### **Addendum 9: United Nations Global Technical Regulation No. 9**

**United Nations Global Technical Regulation on Pedestrian Safety**

#### **Amendment 2**

Established in the Global Registry on 14 November 2018

"Figure 5A

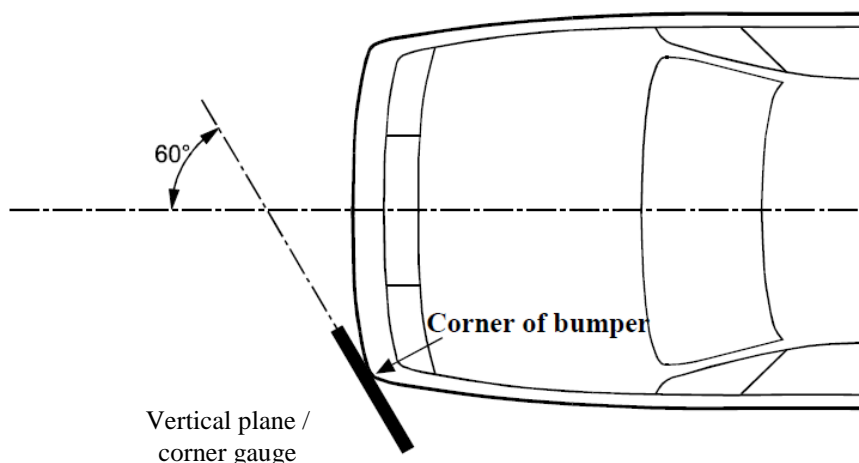
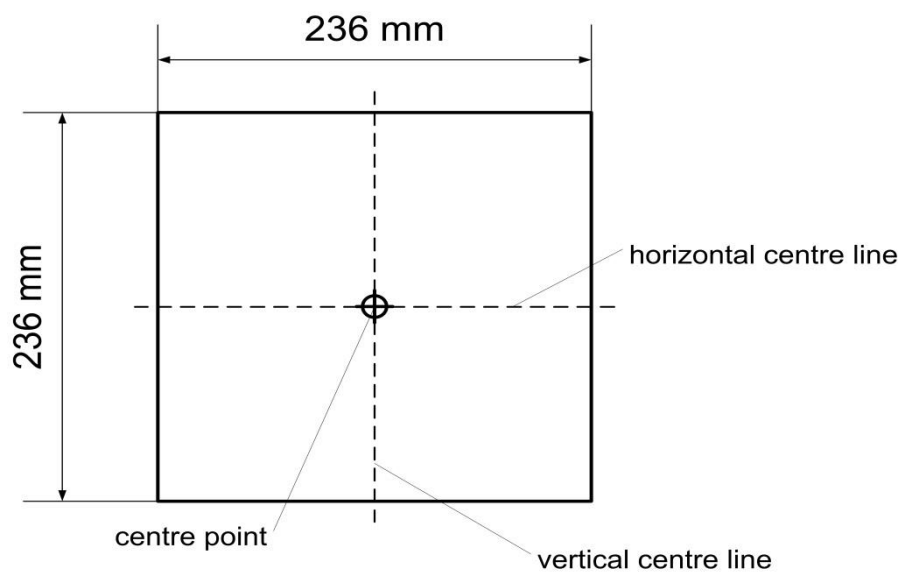
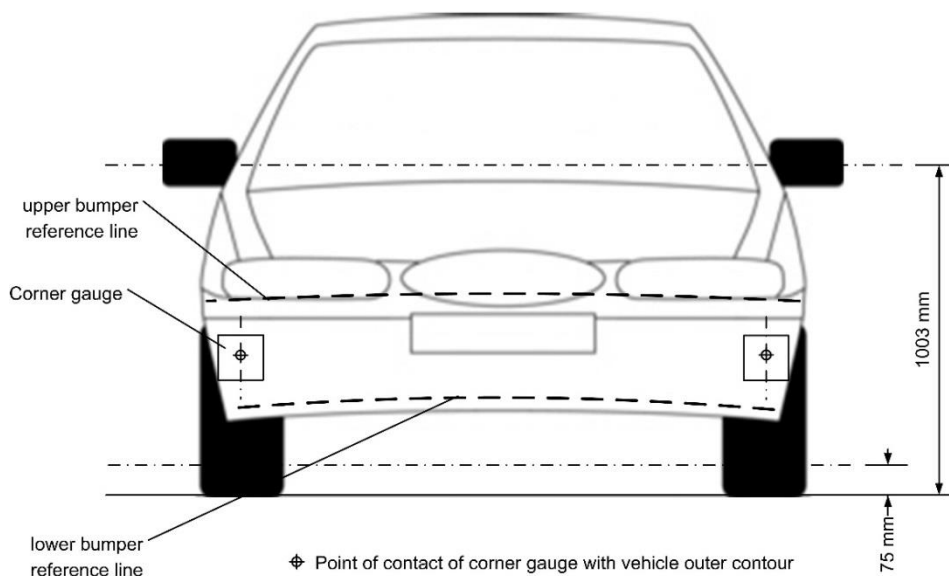
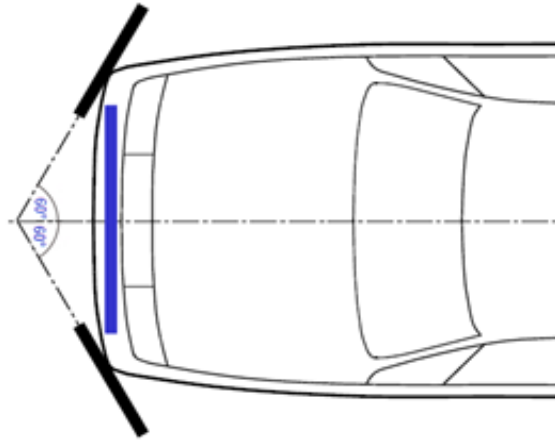
- "3.14. "Corner of bumper" means the transversal position of the vehicle's point of contact with a corner gauge as defined in Figure 5B.

For determination of the corner of bumper, the front surface of the corner gauge is moved parallel to a vertical plane with an angle of 60° to the vertical longitudinal centre plane of the vehicle (see Figures 5A and 5C) at any height of the centre point of the corner gauge between:

- (a) Equal to and above the point found on the vertical line intersecting the Lower Bumper Reference Line at the assessment position in transversal direction or at 75 mm above the ground reference plane, whichever is higher.
- (b) Equal to and below the point found on the vertical line intersecting the Upper Bumper Reference Line at the assessment position in transversal direction or at 1,003 mm above the ground reference plane, whichever is lower.

For determination of the corner of bumper, the gauge is moved to contact the outer contour/front fascia of the vehicle touching at the vertical centre line of the gauge. The horizontal centre line of the gauge is kept parallel to the ground plane.

Figure 5, amend to read:

"Figure 12

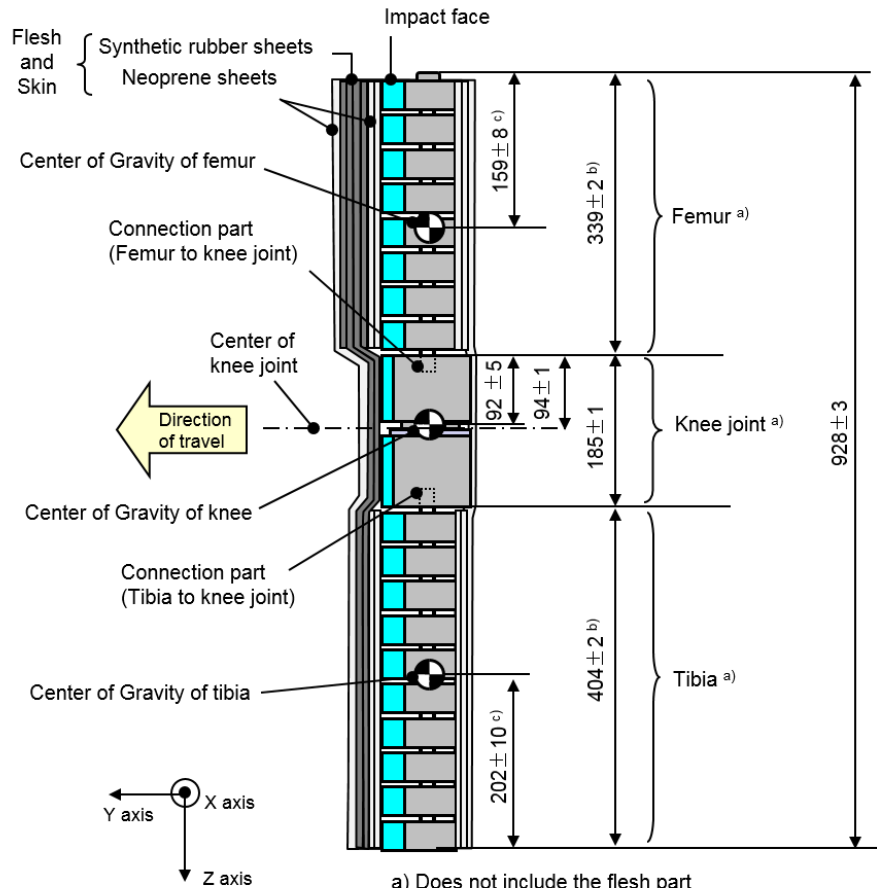
The flexible lower legform impactor shall consist of the flesh and skin, flexible long bone segments (representing femur bone and tibia bone), and the knee joint as shown in Figure 12.<sup>2</sup>

The assembled impactor shall have a total mass of  $13.2 \pm 0.4$  kg. The dimensions of the fully assembled impactor shall be as defined in Figure 12, measured at the vertical centre line.

The centres of gravity of the femur and tibia without the flesh and skin, including the connection parts to the knee joint, shall be as defined in Figure 12. The centre of gravity of the knee joint shall be as defined in Figure 12.

*Figure 12, shall be deleted:*

Figure 13

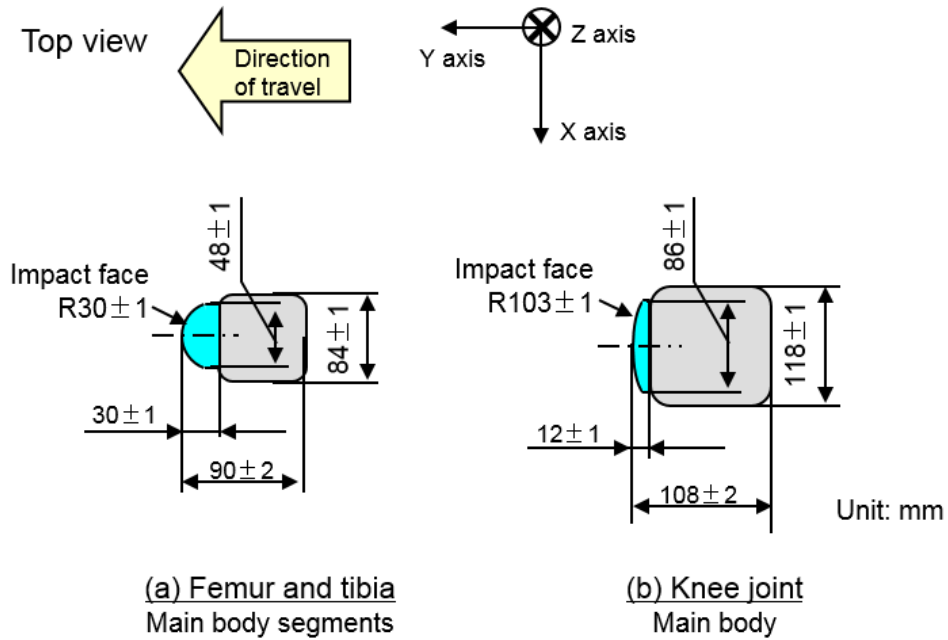
"6.3.1.1.1. The cross-sectional shape of the femur main body segments, the tibia main body segments and their impact faces shall be as defined in Figure 13 (a).

6.3.1.1.2. The cross-sectional shape of the knee joint and its impact face shall be as defined in Figure 13 (b).

Figure 14

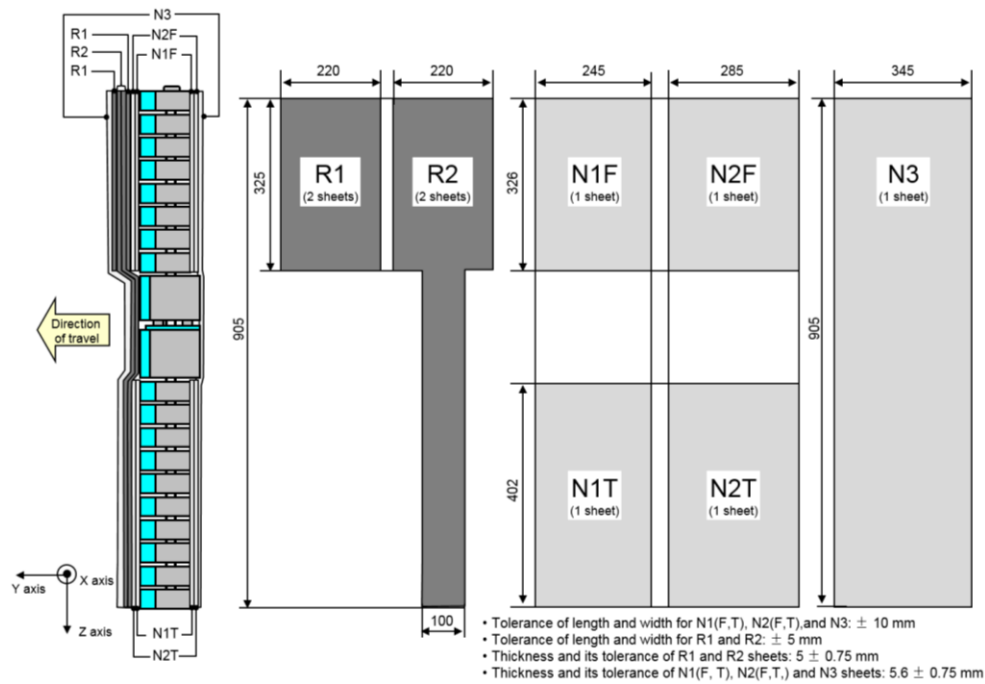
6.3.1.1.4. For each test, the impactor (femur, knee joint and tibia without flesh and skin) shall be covered by the flesh and skin composed of synthetic rubber sheets (R1, R2) and foamed neoprene sheets (N1F, N2F, N1T, N2T, N3) as shown in Figure 14. The size of the sheets shall be within the requirements described in Figure 14. The sheets are required to have compression characteristics as

Figure 15

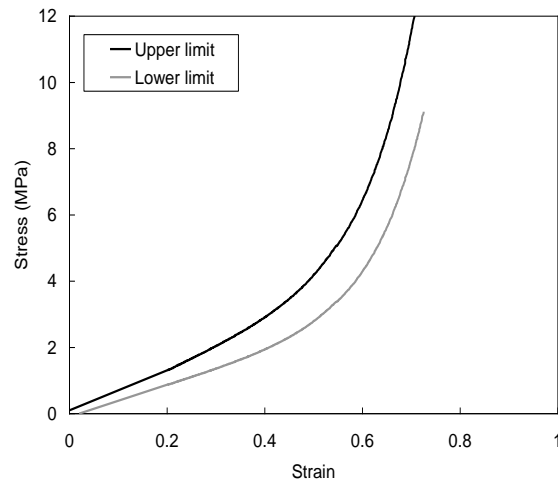
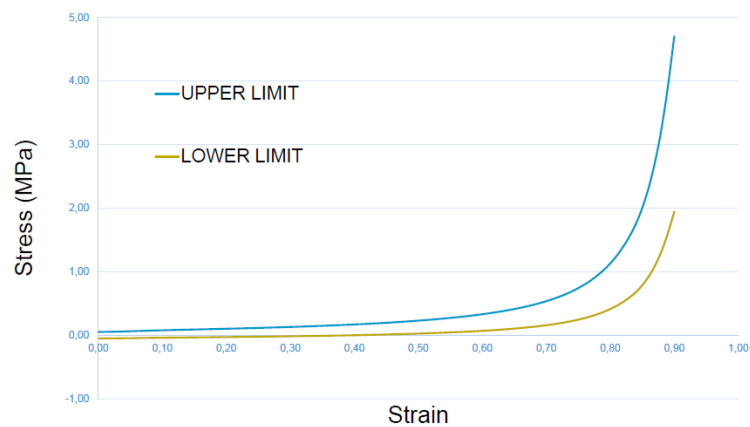
shown in Figure 15. The compression characteristics shall be checked using material from the same batch as the sheets used for the impactor flesh and skin.

Figure 16  
Flexible lower legform impactor: Location of the transducers

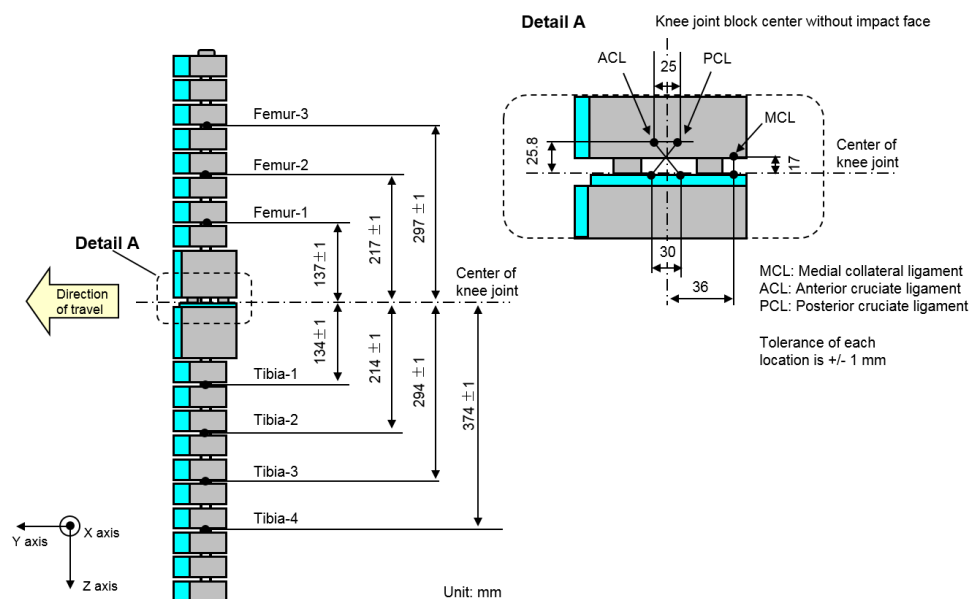
Three transducers shall be installed in the femur to measure bending moments applied to the femur. The sensing locations of each of the transducers are as defined in Figure 16.

"Figure 20  
Tolerances of angles for the flexible lower legform impactor at the time of the first impact.....

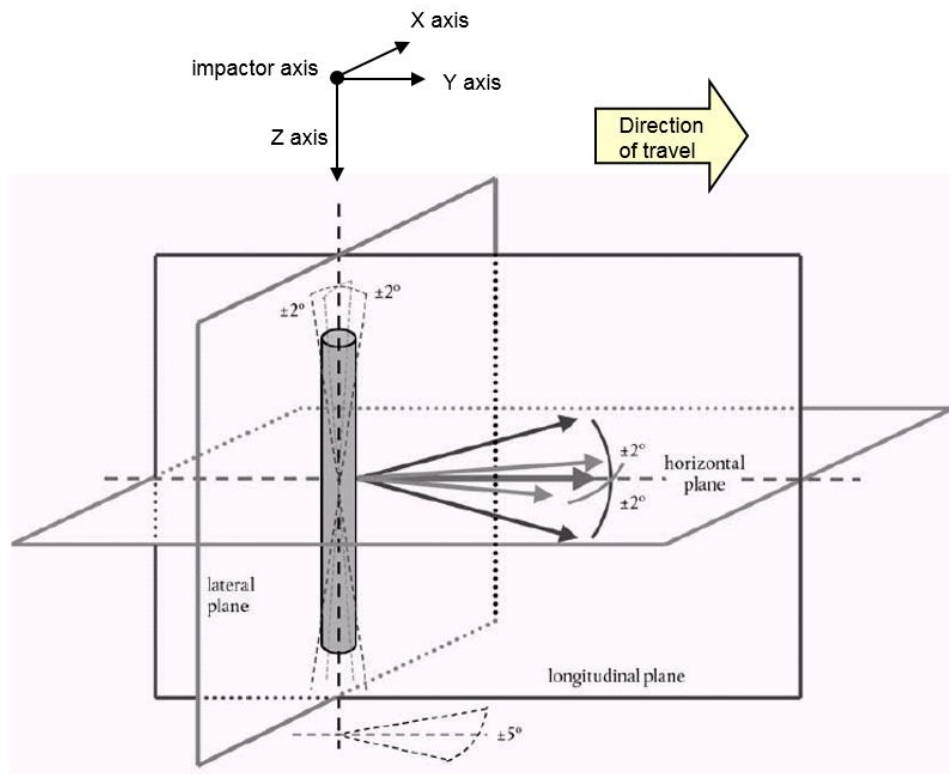
7.1.1.2. The direction of the impact velocity vector shall be in the horizontal plane and parallel to the longitudinal vertical plane of the vehicle. The tolerance for the direction of the velocity vector in the horizontal plane and in the longitudinal plane shall be  $\pm 2^\circ$  at the time of first contact. The axis of the impactor shall be perpendicular to the horizontal plane, with a roll and pitch angle tolerance of  $\pm 2^\circ$  in the lateral and longitudinal plane. The horizontal, longitudinal and lateral planes are orthogonal to each other (see Figure 20).

7.1.1.3.2. At the time of first contact the impactor shall have the intended orientation about its vertical axis, for the correct operation of its knee joint, with a yaw angle tolerance of  $\pm 5^\circ$  (see Figure 20)."

*Figures 16 and 17 (former), renumber as Figures 20 and 21 and amend to read:*

Figure 21

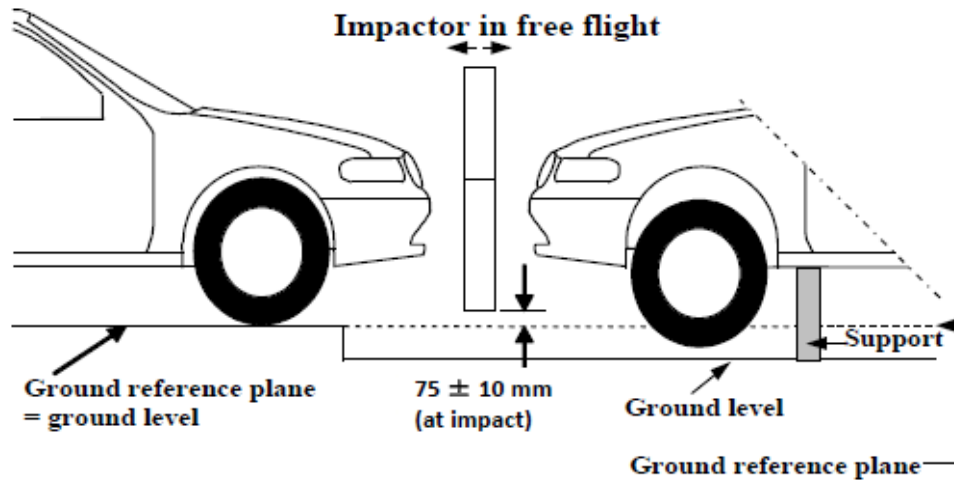
7.1.1.3. The bottom of the impactor (without parts needed for the purposes of launching and/or protection) shall be 75 mm above the ground reference plane at the time of the first contact with the bumper (see Figure 21), with a tolerance of  $\pm 10$  mm. When setting the height of the propulsion system, an allowance shall be made for the influence of gravity during the period of free flight of the impactor.

Figure 22

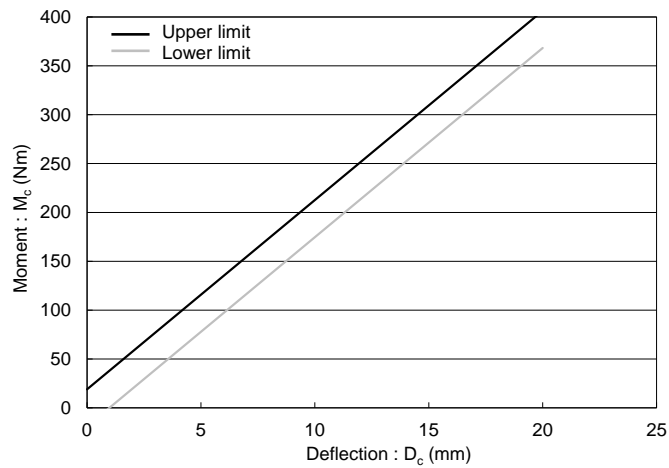
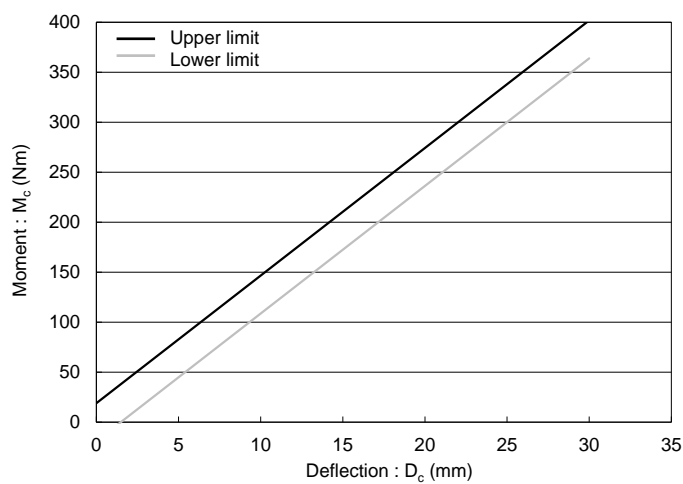
- 8.1.1.2. When the femur and the tibia of the impactor, without flesh and skin, are loaded in bending in accordance with paragraph 8.1.1.4., the applied moment and the generated deflection at the centre of the femur and the tibia ( $M_c$  and  $D_c$ ) shall be within the corridors shown in Figure 22.

Figure 23  
**Flexible lower legform impactor: Requirement corridors for the knee joint, without flesh and skin, in the static certification test (see paragraph 8.1.1.3.)**

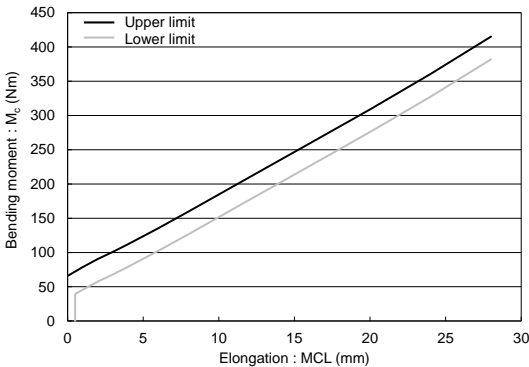
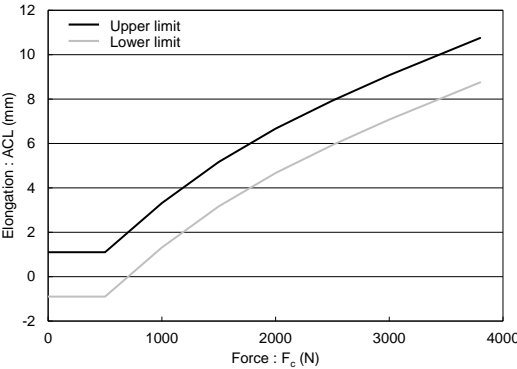
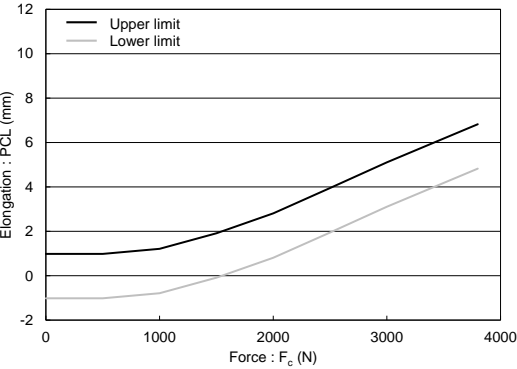
- 8.1.1.3. When the knee joint of the impactor, without flesh and skin, is loaded in bending in accordance with paragraph 8.1.1.5., the MCL, ACL, and PCL elongations and applied bending moment or the force at the centre of the knee joint ( $M_c$  or  $F_c$ ) shall be within the corridors shown in Figure 23.

Figure 24  
**Flexible lower legform impactor: Test set-up for the femur in the static certification test**  
 (see paragraph 8.1.1.4.)

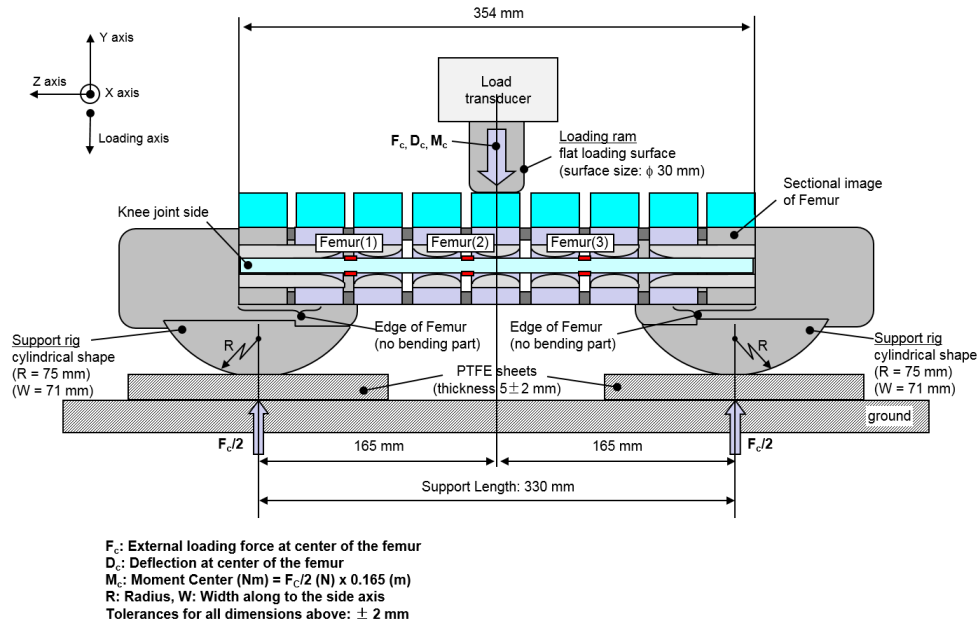
- 8.1.1.4. The edges of the femur and tibia, without flesh and skin, not bending parts, shall be mounted to the support rig firmly as shown in Figure 24 and Figure 25. The Y-axis of the impactor shall be parallel to the loading axis within  $180 \pm 2^\circ$  tolerance. To obtain repeatable loading, low friction Polytetrafluoroethylene (PTFE) plastic pads are used under each support (see Figures 24 and 25).

Figure 26  
Flexible lower legform impactor: Test set-up for the knee joint in the static certification test (see paragraph 8.1.1.5.)

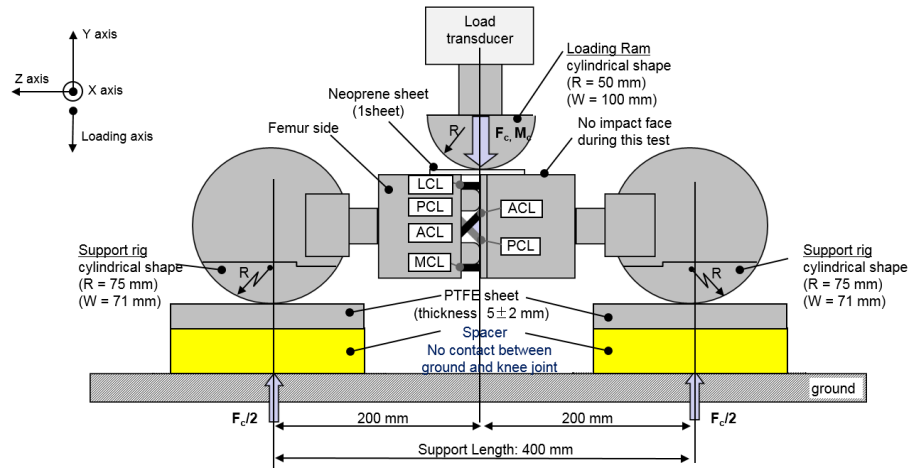
- 8.1.1.5. The ends of the knee joint, without flesh and skin, shall be mounted to the support rig firmly as shown in Figure 26. The Y-axis of the impactor shall be parallel to the loading axis within  $\pm 2^\circ$  tolerance. To obtain repeatable loading, low friction Polytetrafluoroethylene (PTFE) plastic pads are used under each support (see Figure 26). To avoid impactor damage, a foamed neoprene sheet shall be set between the loading ram and the impactor face of the knee joint, which is described in Figure 26, shall be removed. The foamed neoprene sheet used in this test shall have compression characteristics as shown in Figure 15.

- The centre of the loading force shall be applied at the knee joint centre within  $\pm 2^\circ$ mm tolerance along the Z-axis (see Figure 12). The external load shall be increased so as to maintain a deflection rate between 10 and 100 mm/minute until the bending moment at the centre part of the knee joint ( $M_c$ ) reaches 400 Nm.

Figure 27

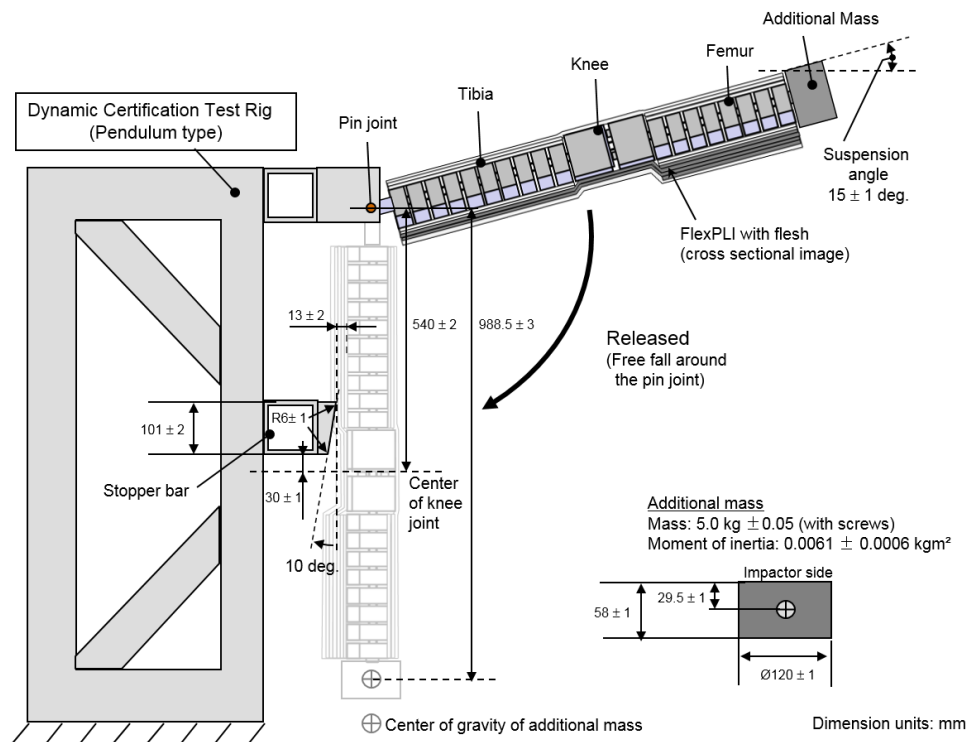
- 8.1.2.4.1. The flexible lower legform impactor, including the flesh and skin, shall be suspended from the dynamic certification test rig  $15 \pm 1^\circ$  upward from the horizontal as shown in Figure 27. The impactor shall be released from the suspended position and fall freely against the pin joint of the test rig as shown in Figure 27.

- 8.1.2.4.2. The knee joint centre of the impactor shall be  $30 \pm 1 \text{ mm}$  below the bottom line of the stopper bar, and the tibia impact face without the flesh and skin shall be located  $13 \pm 2 \text{ mm}$  from the front upper edge of the stopper bar when the impactor is hanging freely as shown in Figure 27. "
